TVA-SQN-TS-60

PROPOSED TECHNICAL SPECIFICATIONS

SEQUOYAH NUCLEAR PLANT
UNITS 1 AND 2

FIGURE 6.2-1
OFFSITE ORGANIZATION FOR FACILITY MANAGEMENT AND TECHNICAL SUPPORT

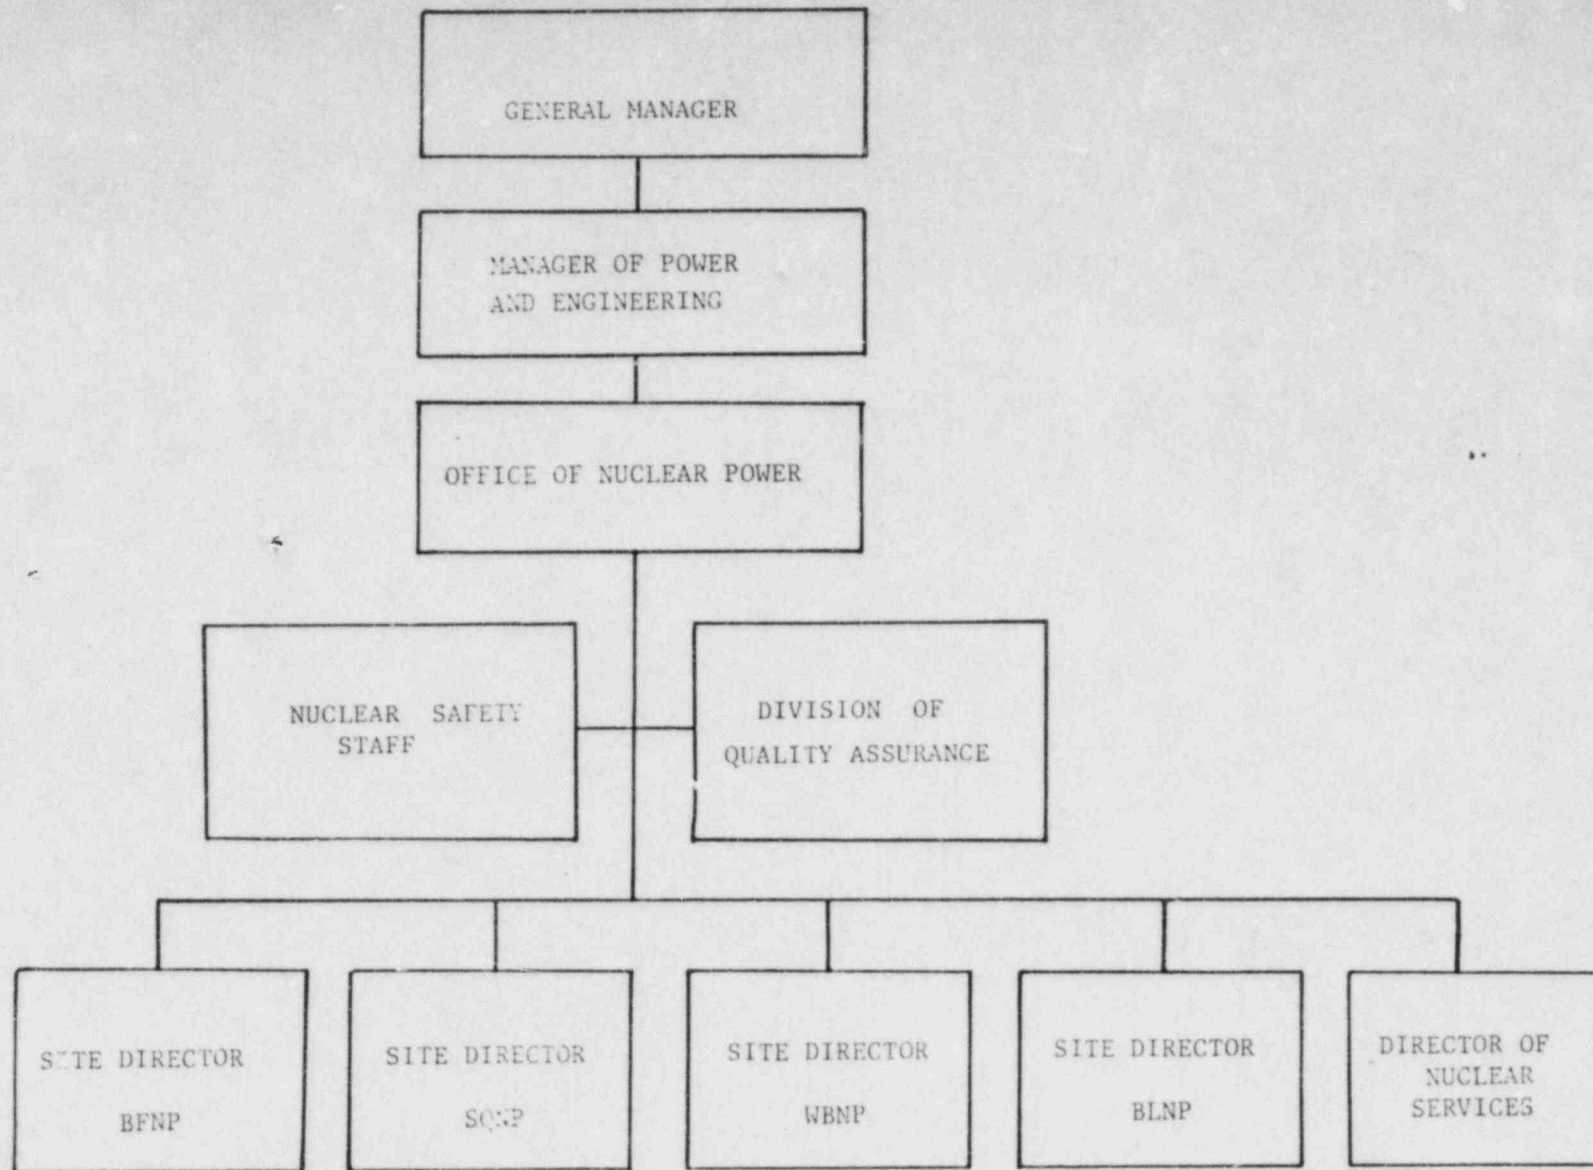
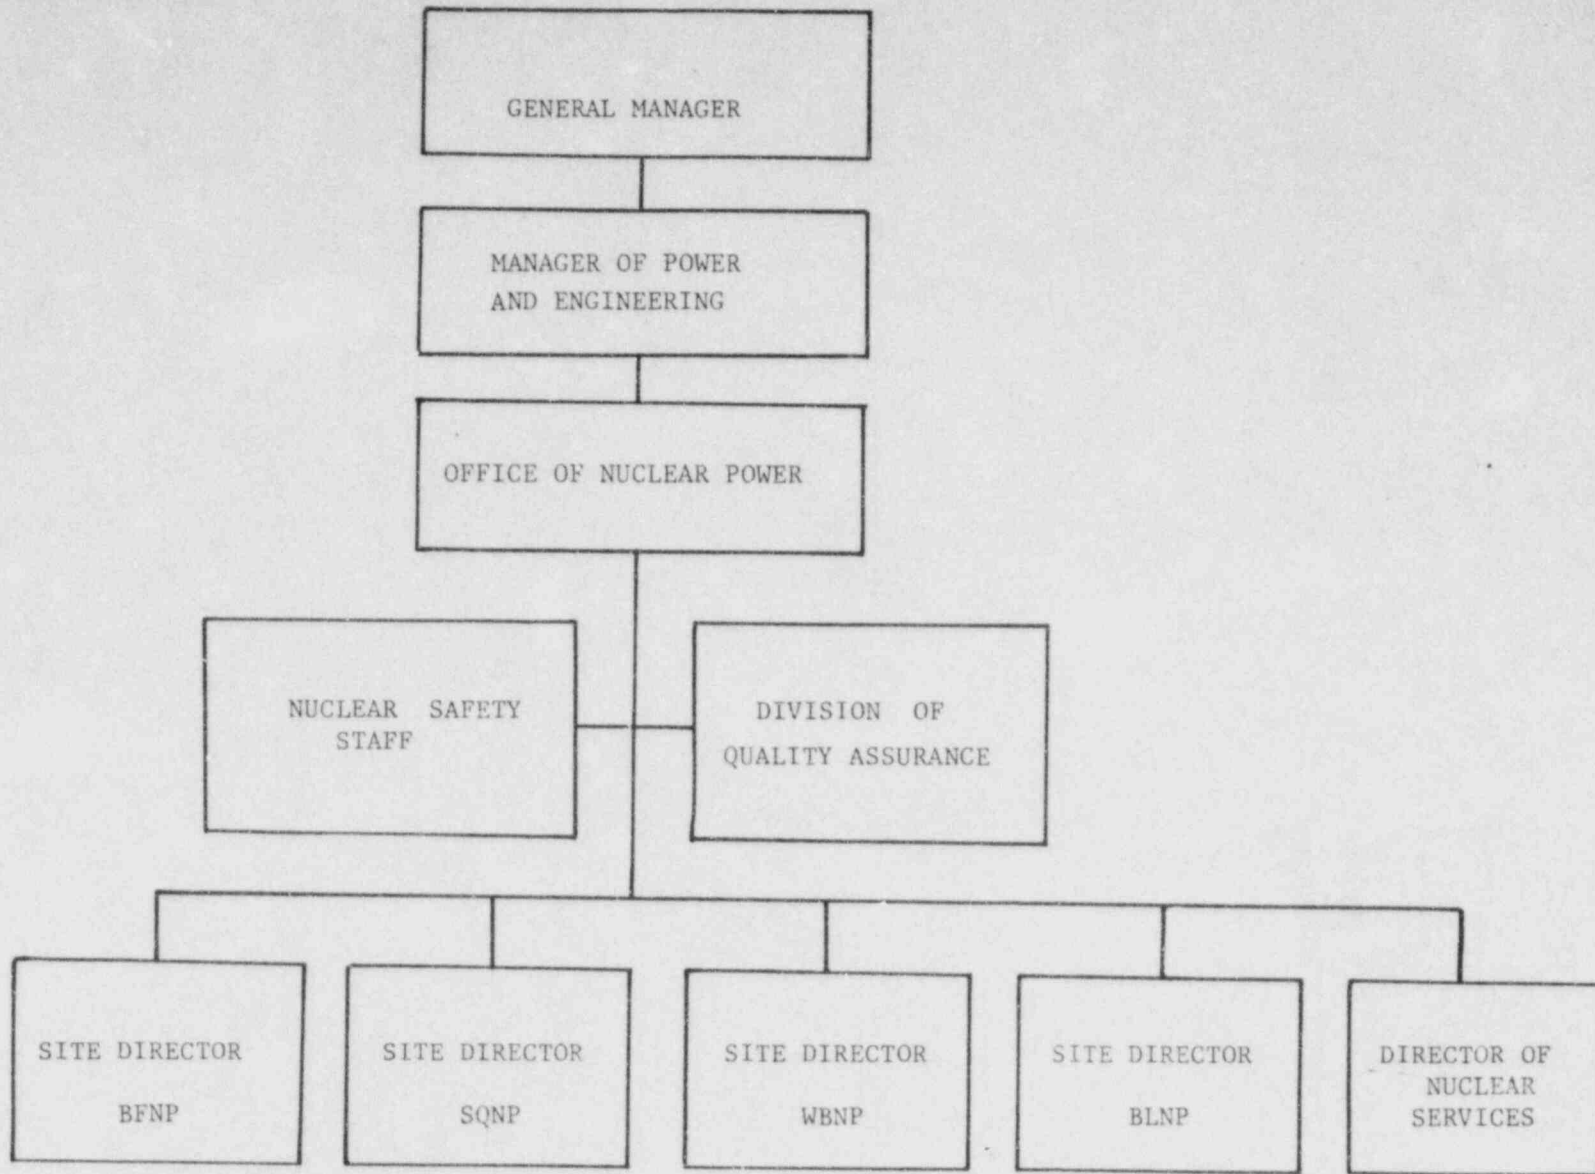
The plant organization shown in Figures 6.1-1, -2, and -3 have been changed to reflect the recent reorganization. This change does not directly impact safety. These changes are administrative only in nature.

FIGURE 6.2-2
FACILITY ORGANIZATION

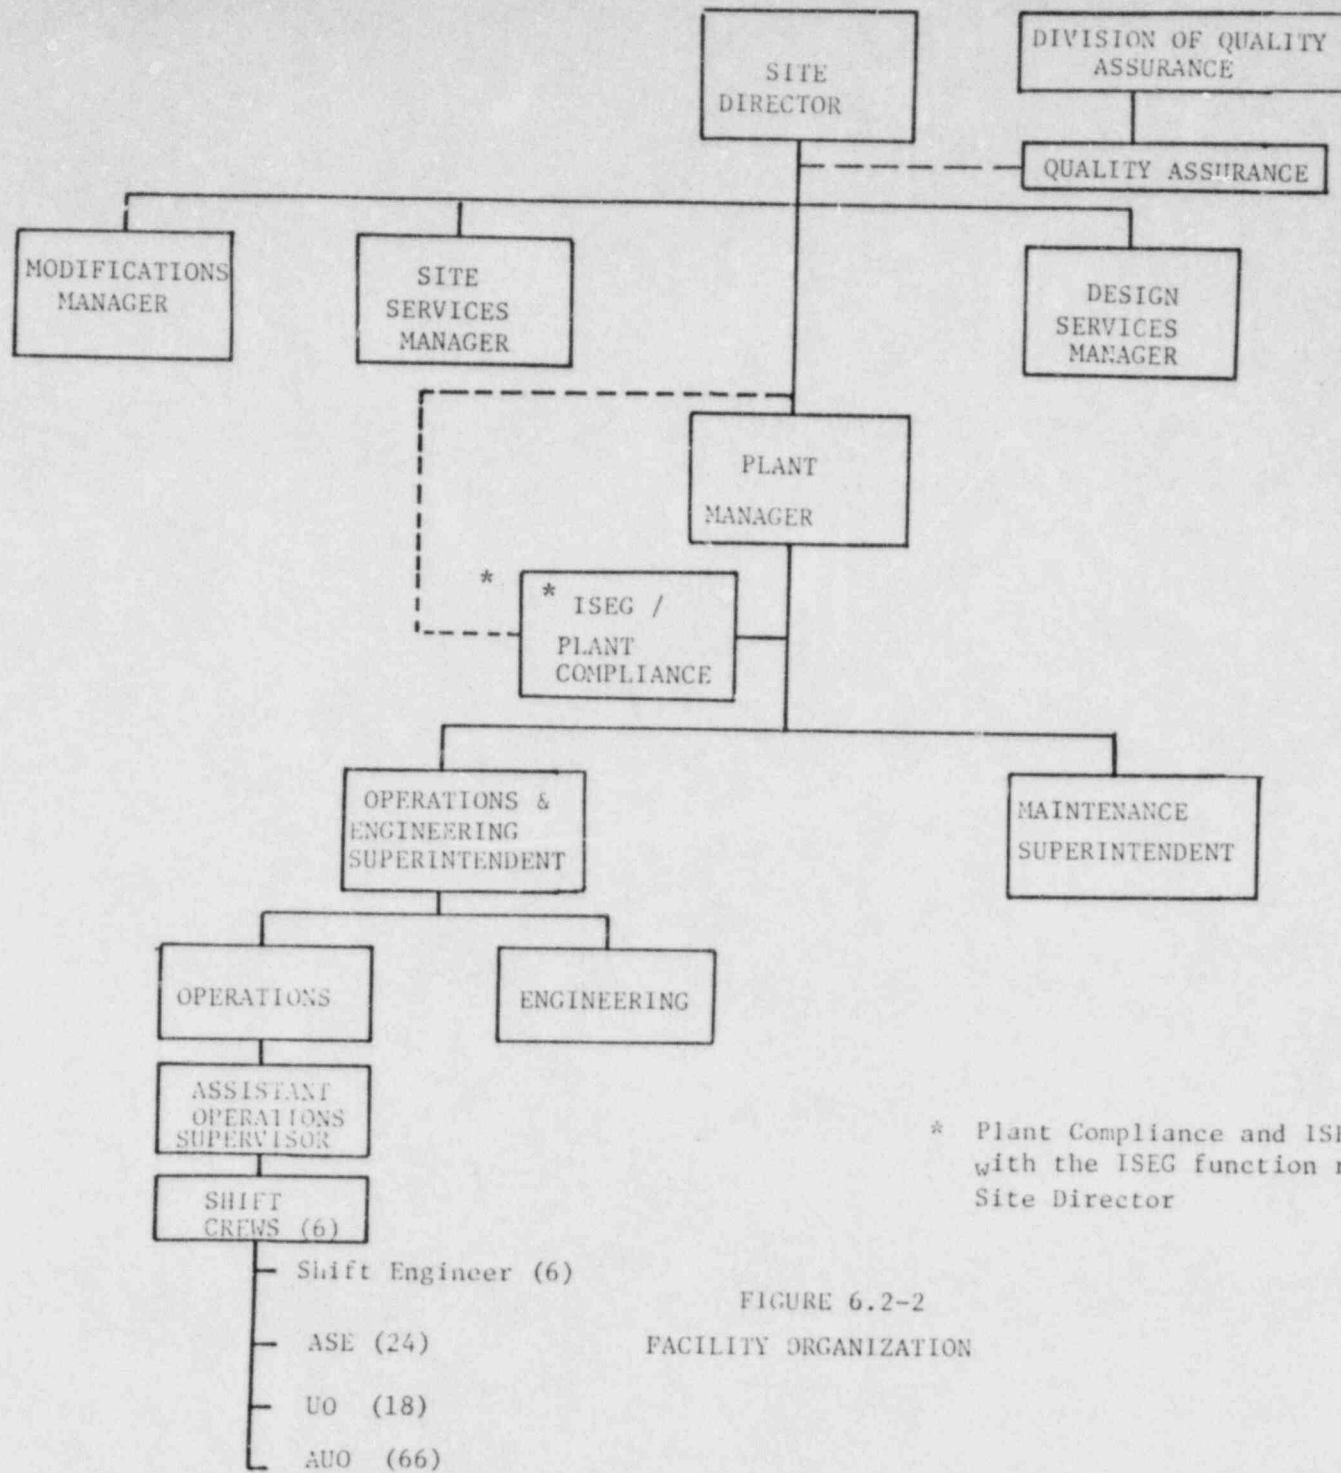
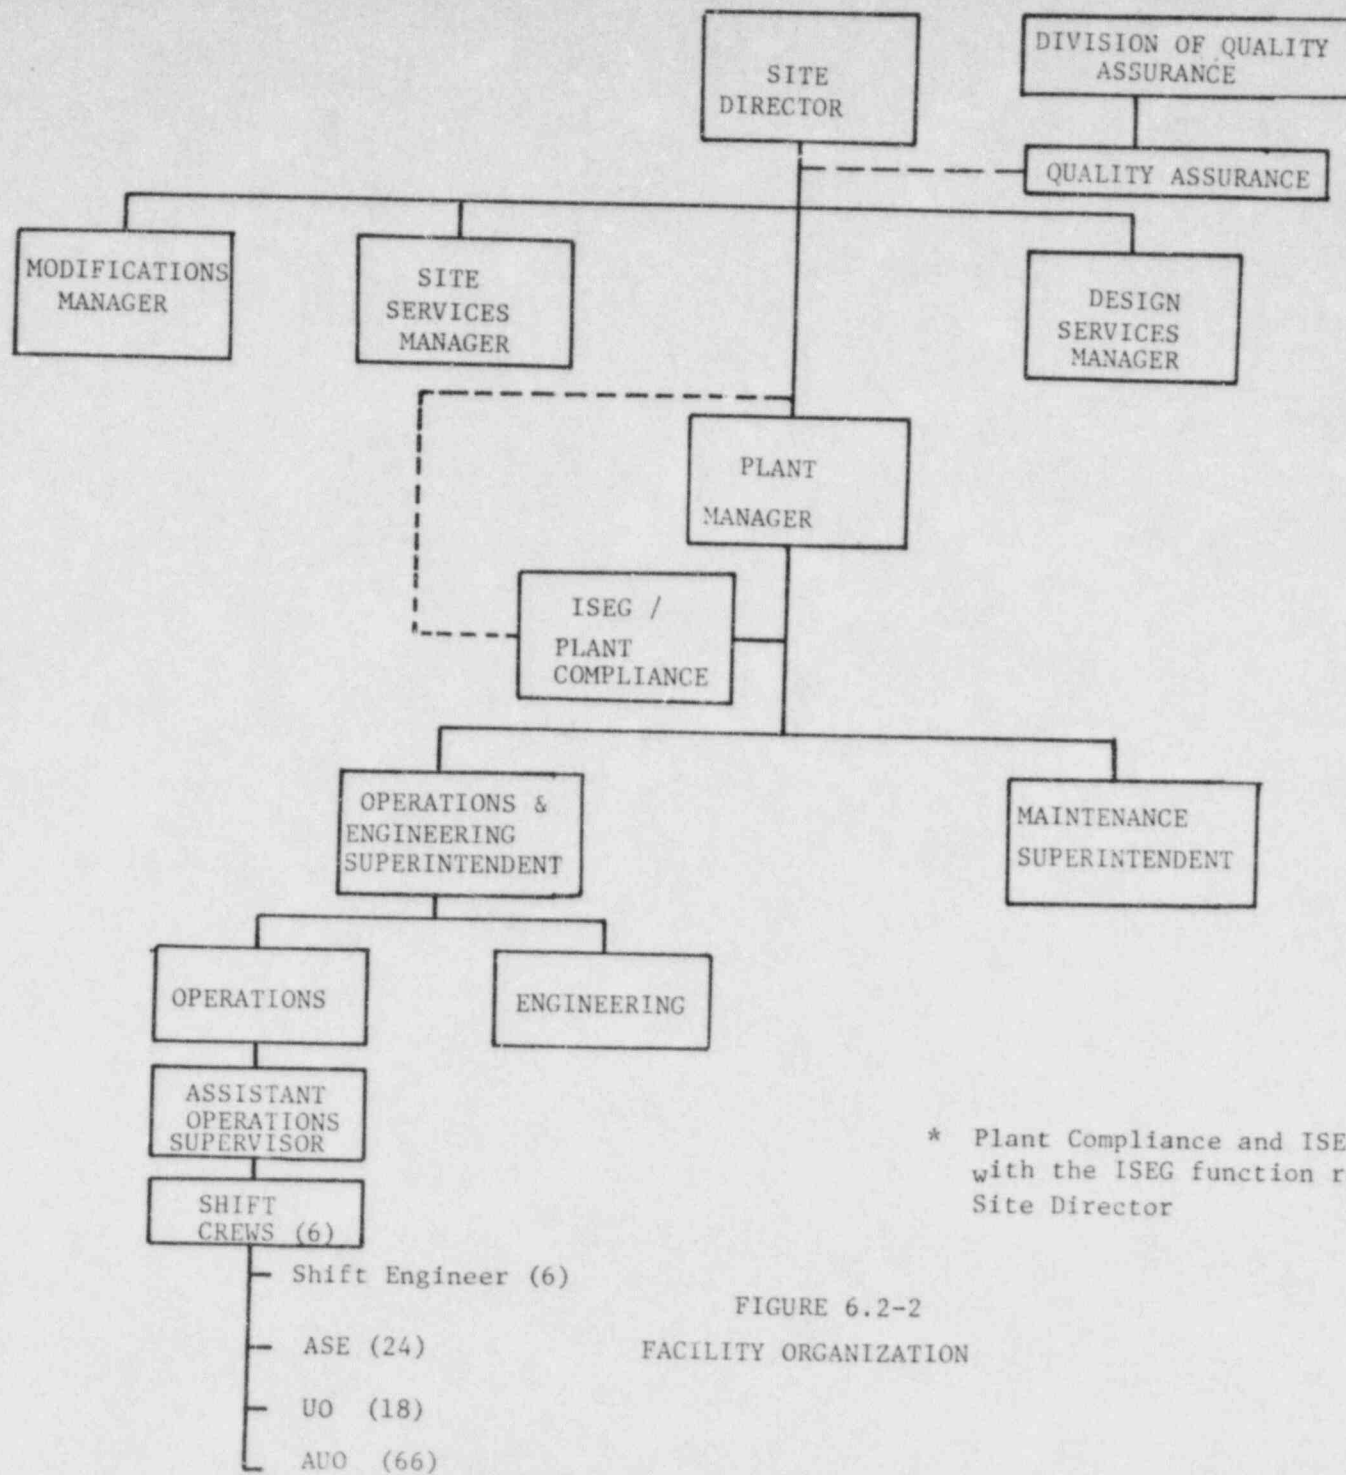
* Plant Compliance and ISEG are the same group with the ISEG function reporting to the Site Director

These changes are being requested to reflect the current status of the ISEG within the facility organization. Refer to revised figure 6.2-2. The ISEG will now report to the Site Director as a result of a recent TVA reorganization. Also a change is being requested to delete the term "dedicated" from 6.2.3.2.

FIGURE 6.2-3
 ORGANIZATION FOR MONITORING PROGRAM AND DOSE CALCULATIONS

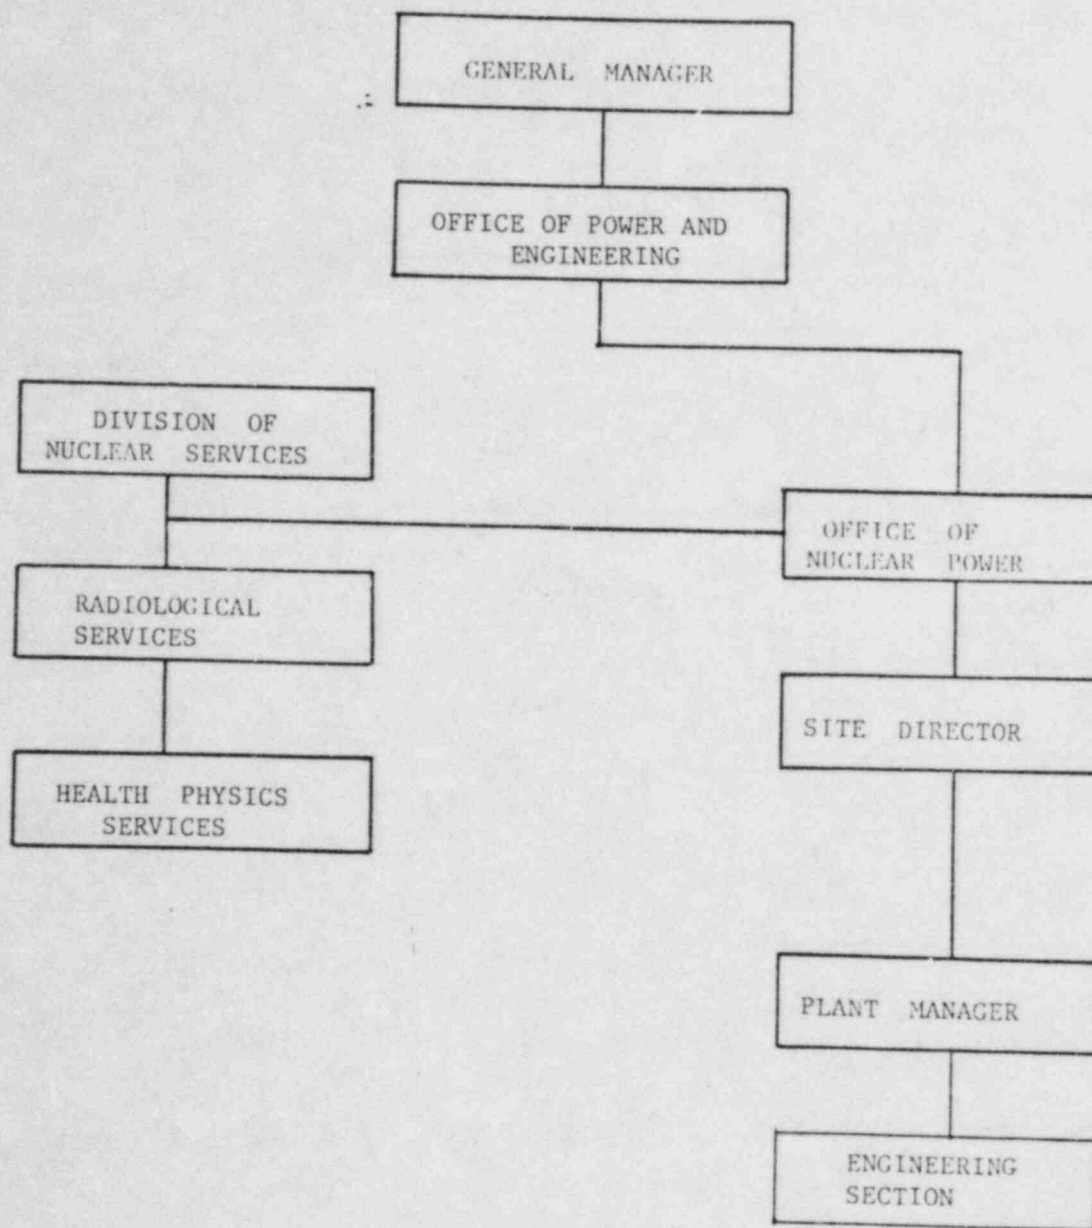
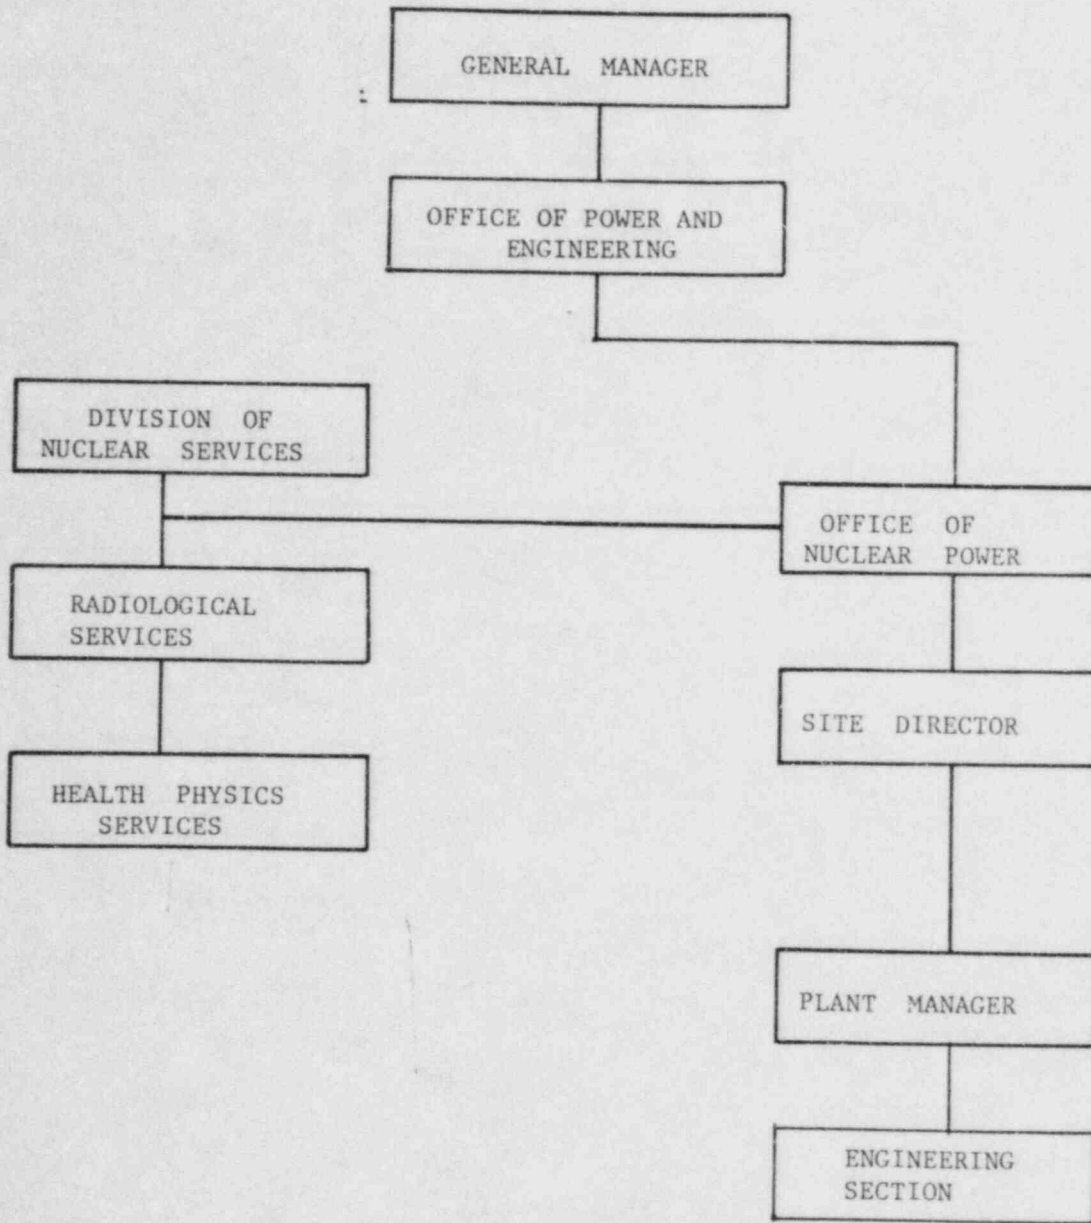
The plant organization shown in Figures 6.1-1, -2, and -3 have been changed to reflect the recent reorganization. This change does not directly impact safety. These changes are administrative only in nature.
